SERVICETEKNOTES

TABLE OF CONTENTS

SC504 HALO SUPPRESSION ADDED (cont.)

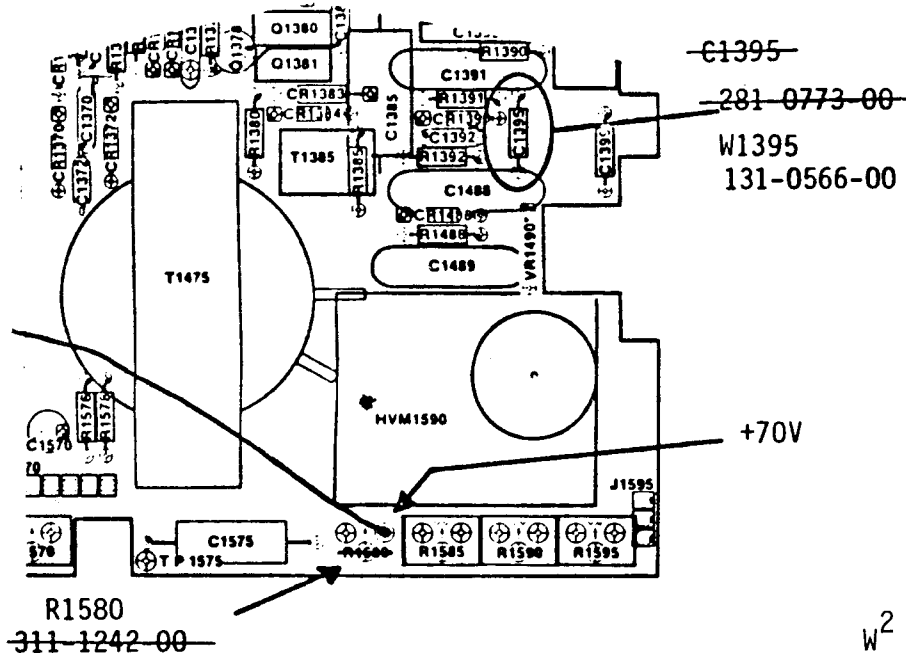
instruments, a new CRT must be added along with the following circuit changes:

1. V1000 CRT changes to P/N 154-0859-00
2. C1395 replaced with W1395, wirestrap, P/N 131-0566-00.

3. R1580 removed.

4. Add a 6 inch length of wire from pin 13 of the CRT socket to the +70 volt terminal from which R1580 was removed.

Figure 5-1. Component Locations, D70 Main Board
 Backside of Circuit Board
 C510 & C513
 Remove: 4.7uf(283-0194-00)
 Add: 0.22uf(285-1241-00)
 C511 & C512
 Remove: 4.7uf(283-0194-00)
 Add: 0.22uf(285-1241-00)

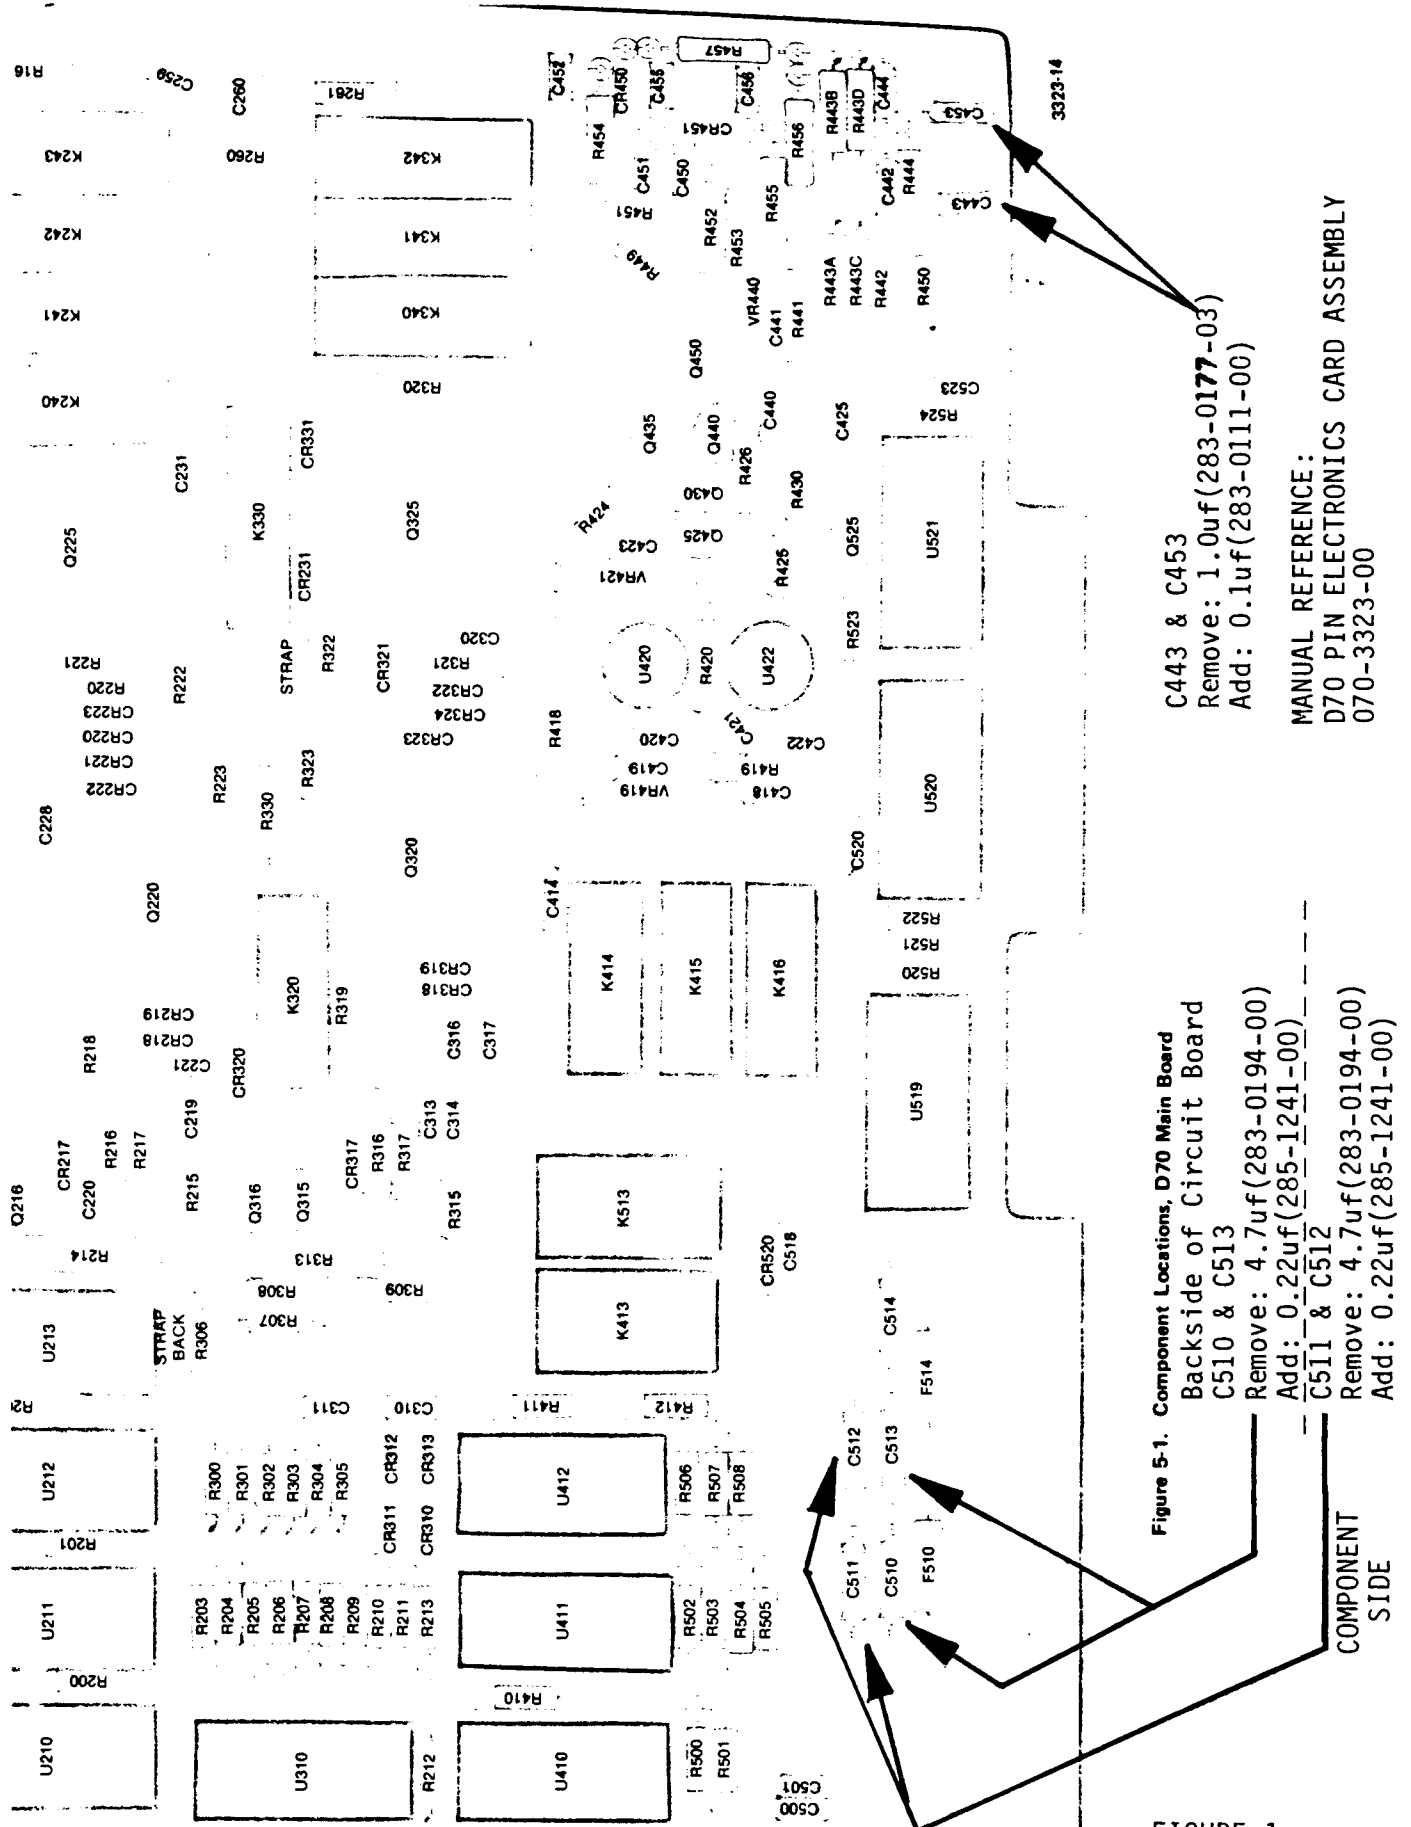
C443 & C453
 Remove: 1.0uf(283-0177-03)
 Add: 0.1uf(283-0111-00)
 MANUAL REFERENCE:
 D70 PIN ELECTRONICS CARD ASSEMBLY
 070-3323-00

FIGURE 1

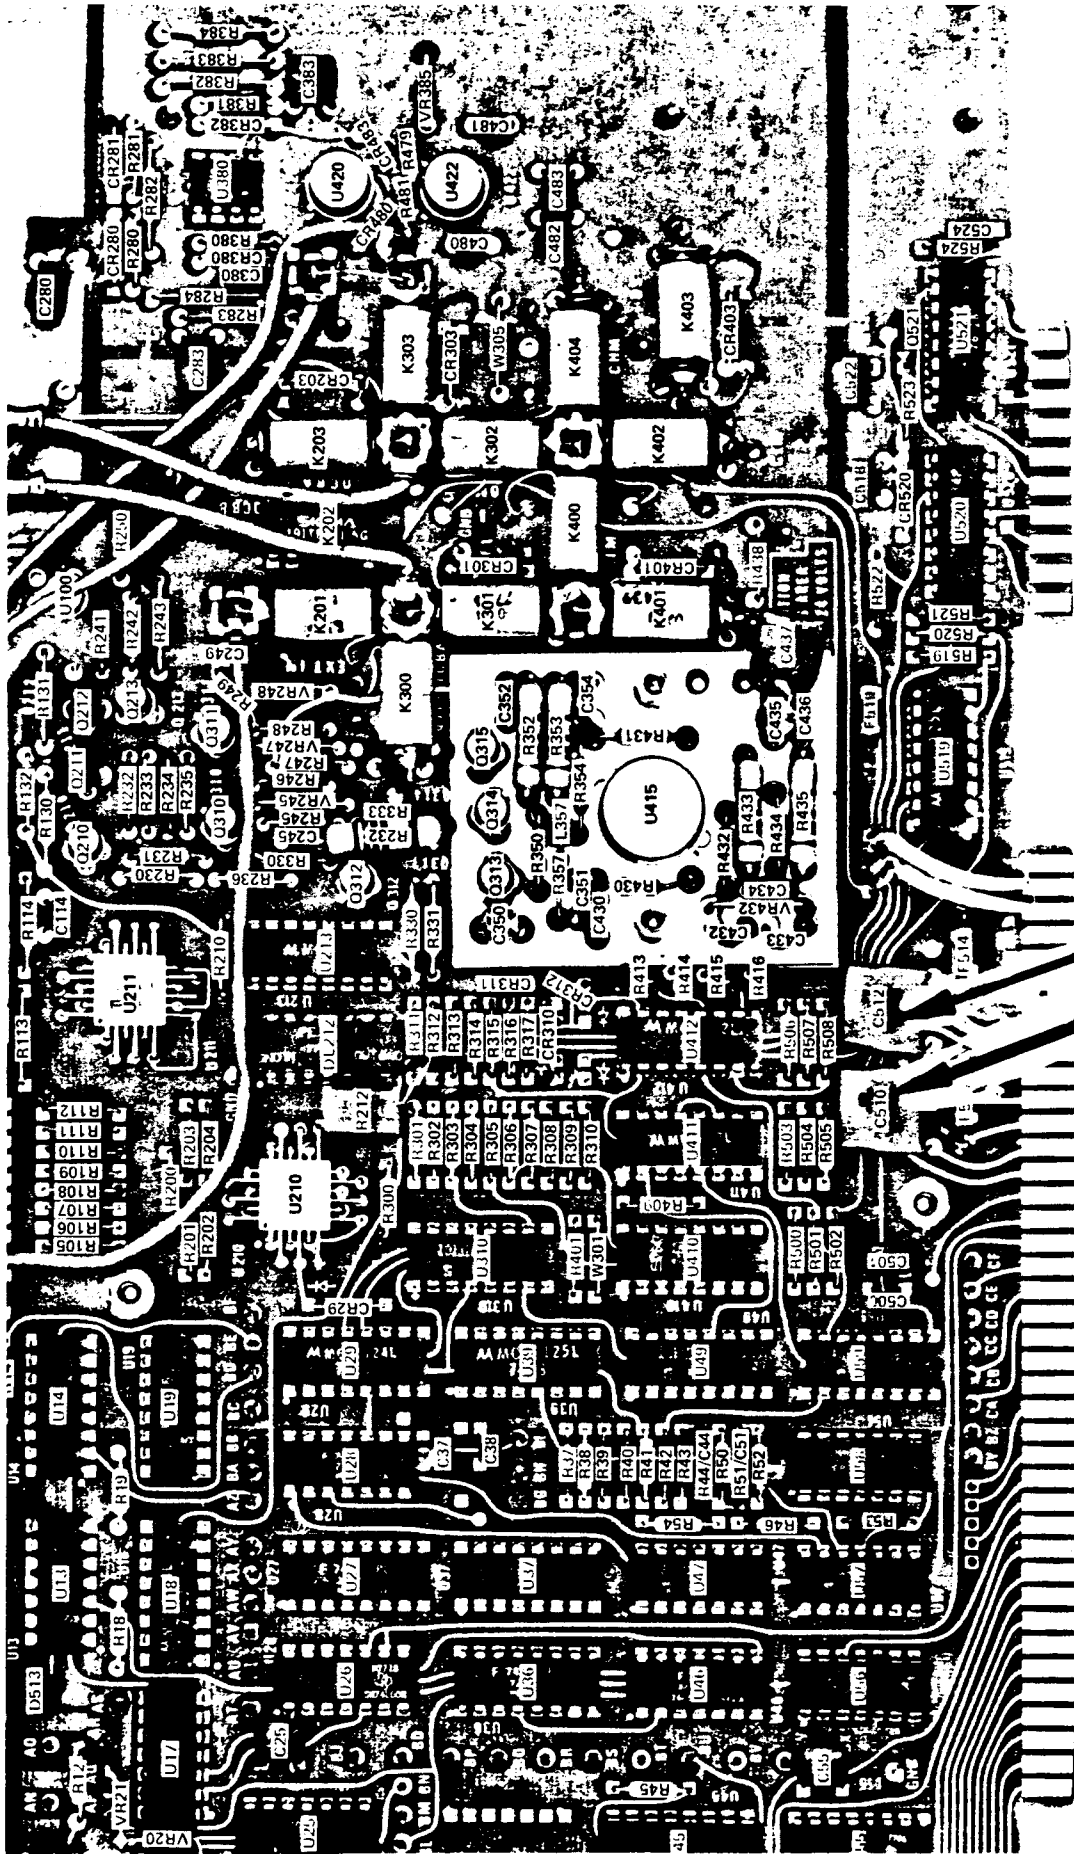
- C512 Remove: 4.7uf(283-0295-00)
Add: .22uf(285-1241-00)
- C510 Remove from Front: 4.7uf(283-0194-00)
Add to Backside: .22uf(285-1241-00)
- C511 Remove from Backside: 4.7uf(283-0294-00)
Add to Front: .22uf(285-1241-00)
- C513 Backside Remove: 4.7uf(283-0294-00)
Add: .22uf(285-1241-00)

Figure 4-1. D80 Component Locations (Front)

FIGURE 2

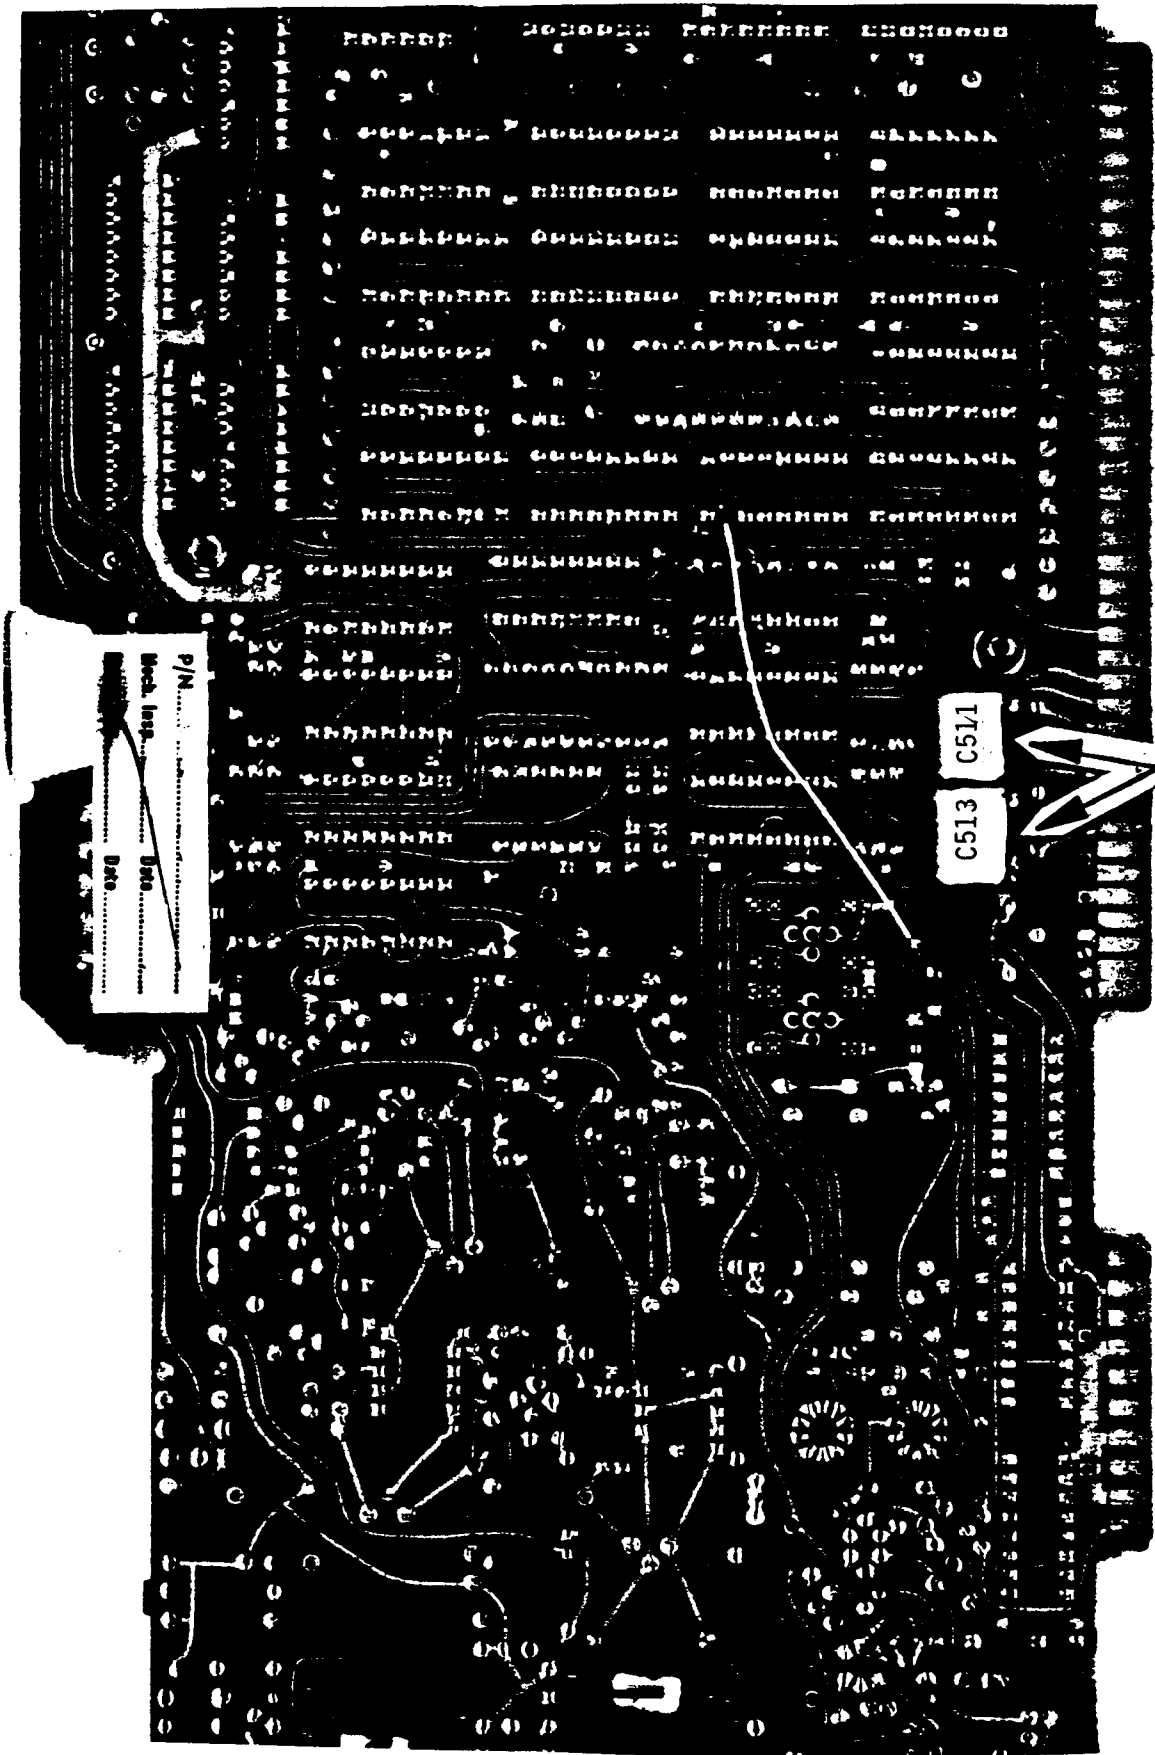
CAPACITOR LOCATIONS FOR D70 & D80 PIN CARDS

D70 & D80 BACKSIDE PIN ELECTRONICS CARDS

FIGURE 3

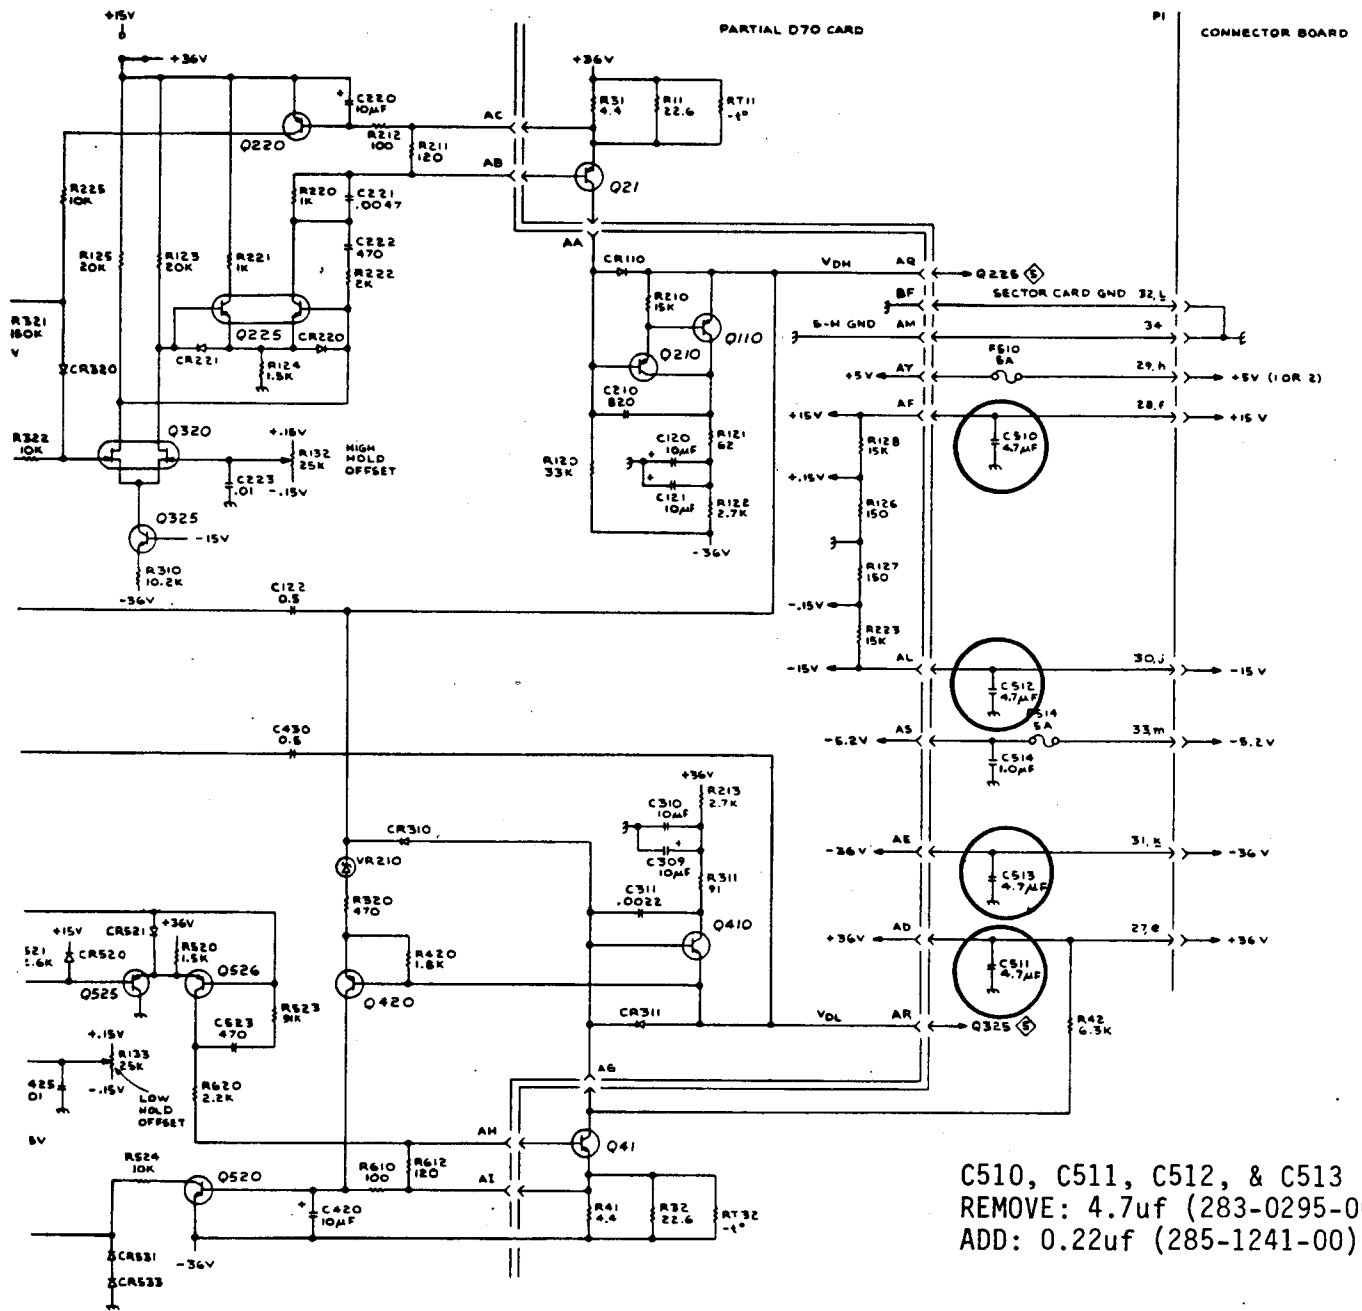
C510, C511, C512, & C513
 REMOVE: 4.7uf (283-0295-00)
 ADD: 0.22uf (285-1241-00)

REFERENCE MANUAL:
 D70 PIN ELECTRONICS CARD
 3323-25 070-3323-00

FIGURE 6

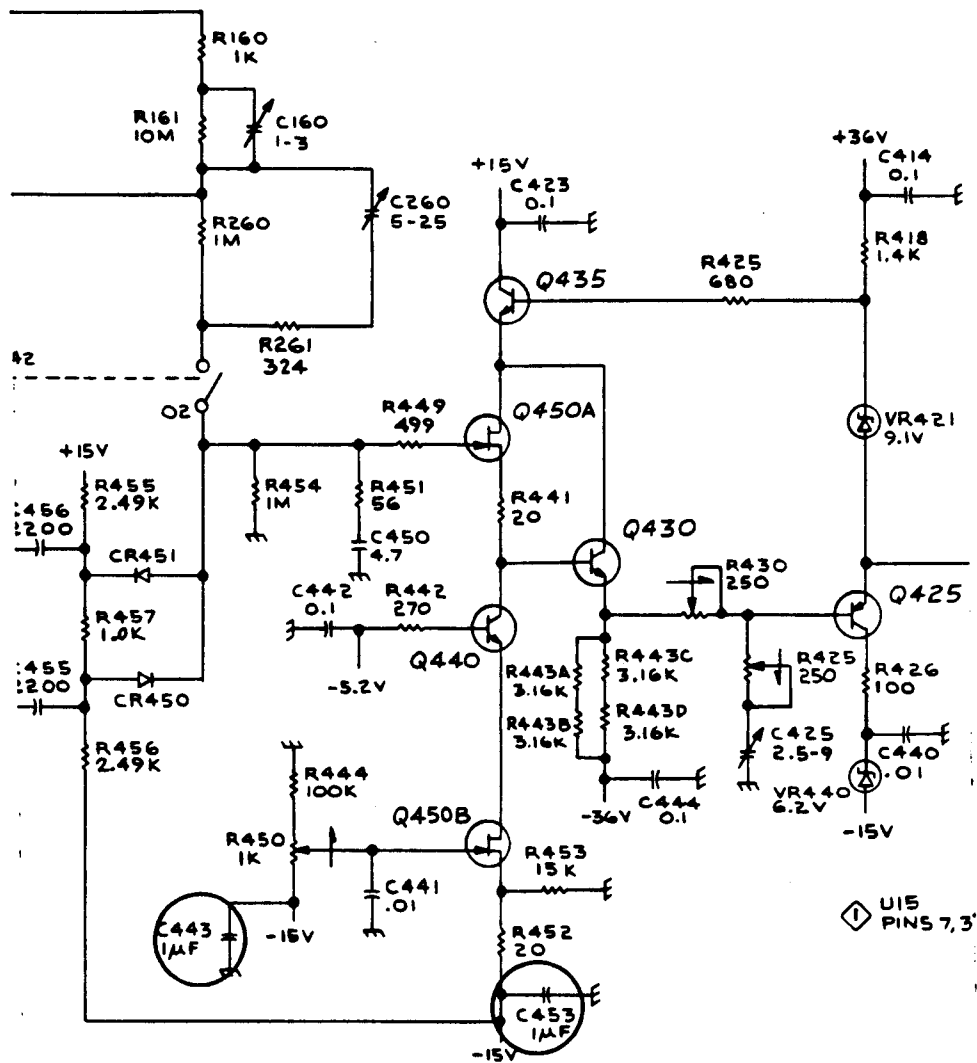
C443 & C453
 REMOVE: 1uf (283-0177-03)
 ADD: 0.1uf (283-0111-00)

REFERENCE MANUAL:
 D70 PIN ELECTRONICS CARD
 070-3323-00

Figure 1

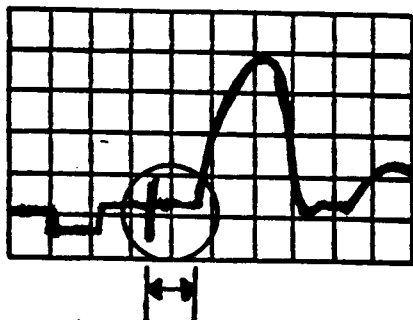
Observe the waveform at the junction of T5090 and L5085/R5085. This should appear similar to the waveform in Figure 1 (above). Figure 1 illustrates the portion of the waveform that is occurring during the conduction time of the damper diode (CR5020 & CR5021). This time should be between 1.5 to 5 usec.

If the conduction time of the damper diode is less than 1.5 usec, the 050 kit should be installed. If the conduction time of the damper diode is greater than 5 usec, use the original values of L5085 and R5085 to bring this time back to the proper value. The original values for these parts are:

Figure 2

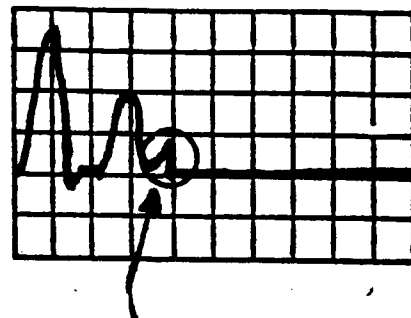
Figure 2 illustrates a waveform that may be seen with the mod kit installed. The extra overshoot noted in the figure is caused by the mod, and is a normal waveform to be expected. This does not affect performance of the circuit.

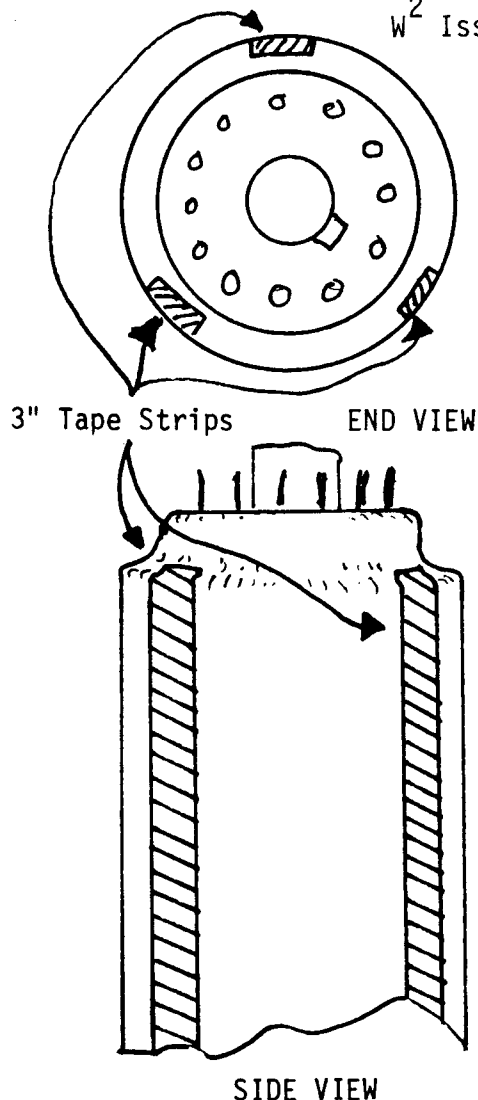
The following change is required per DHEW regulations. Section 9 Maintenance, page 9-23, step 8, overvoltage calibration, change to read:

8. Turn the POWER switch to OFF. Seal R434 with a small amount of Super Glue to prevent further adjustment.
